From: [REDACTED]
Sent: 04 February 2026 16:45
To: Anna Tidey
Cc: Emily Wade
Subject: Re: DM/25/2840 - Windows for Chilcotts, Whitemans Green, Cuckfield.

Subject: Re: FW: DM/25/2840 - Windows and rainwater goods for Chilcotts, Whitemans Green, Cuckfield.

Subject: Re: Recommendation for DM/25/2840 - Chilcotts, Whitemans Green, Cuckfield.

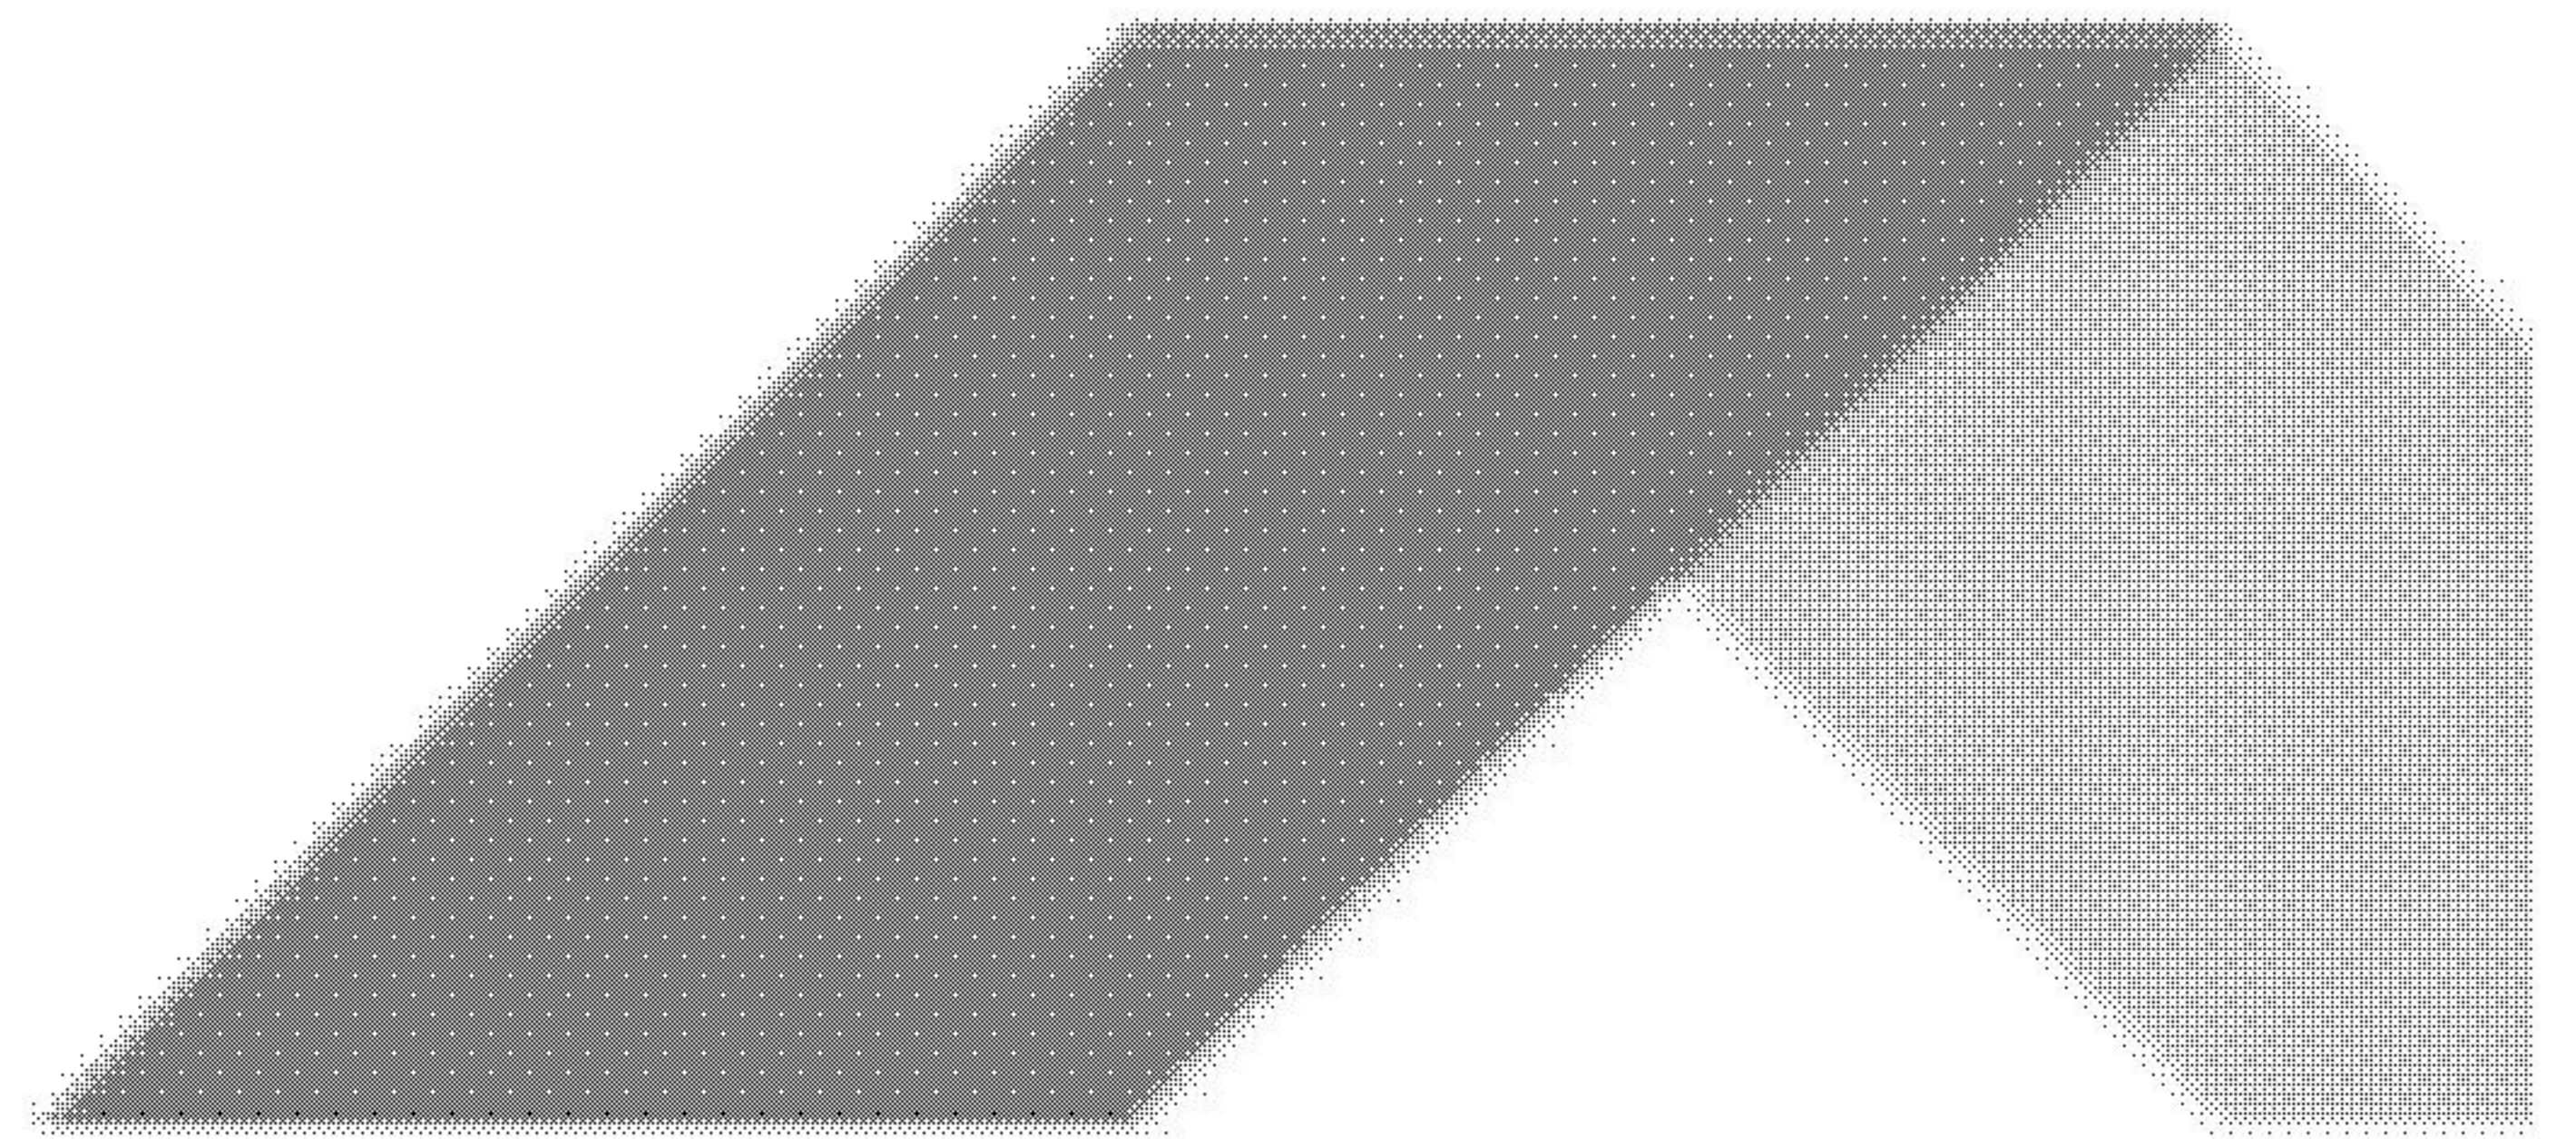
There are many high quality UPVC windows these days which imitate period timber windows very closely, such as this example below:

Would this type of material be acceptable or could we not make the window specification & rainwater details a separate condition, that can be approved later, so that time can be taken to get something suitable, that you approve of?

This matter cannot be the subject of a planning condition. I refer to my comments in my email of 09.01.2026 – *‘the submitted plans for this application show that the existing Georgian style, multi-paned windows in the house are to be replaced with a new style of window to match those shown in the proposed extensions. The application form confirms that the proposed windows are to be of UPVC and the doors of UPVC and aluminium. In my opinion the proposed works that are the subject of this application include the proposed change to the windows in the existing house. I therefore consider the change in the window design in the existing house to be part of the proposed works for which planning approval is being sought.’*

The front, side (south facing) and rear elevations of the house are all open to public inspection from the adjacent public footpath and from the highway. I do not consider that UPVC windows are appropriate any elevation of this property, which is sited in the Whitemans Green Conservation Area, where planning policies seek to enhance the appearance and character of the area.
